Service kit Drive Cable Set (part # 61S4FR6107889)

Service Manual

Doc. no.: 33H4206A

Hollandia 400

Drive cable routing

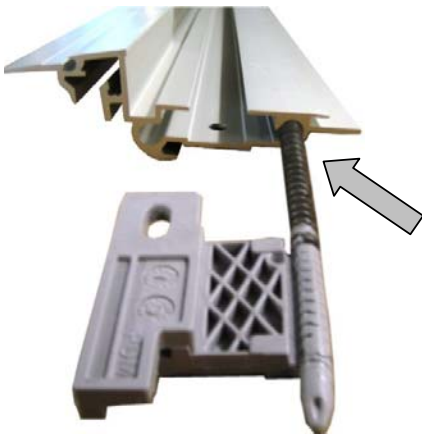
- Hollandia 400 Classic with serial number until 17710: modified routing compared with original;
- Hollandia 400 DeLuxe: same routing as original.

LEFT side of vehicle:
Routing through right (inner) channel.

RIGHT side of vehicle:
Routing through right (outer) channel.

Electrical connection motor Hollandia 400 Classic with serial number until 17710

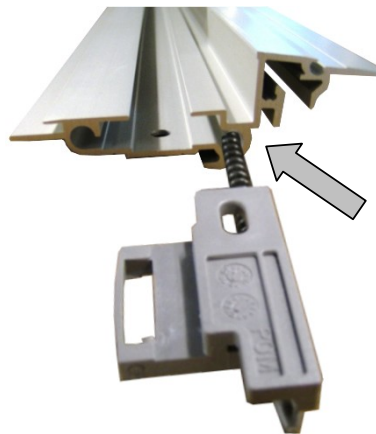
Change the RED and BLACK wires to the motor.

Do NOT change the connection in case you have a Hollandia 400 DeLuxe!
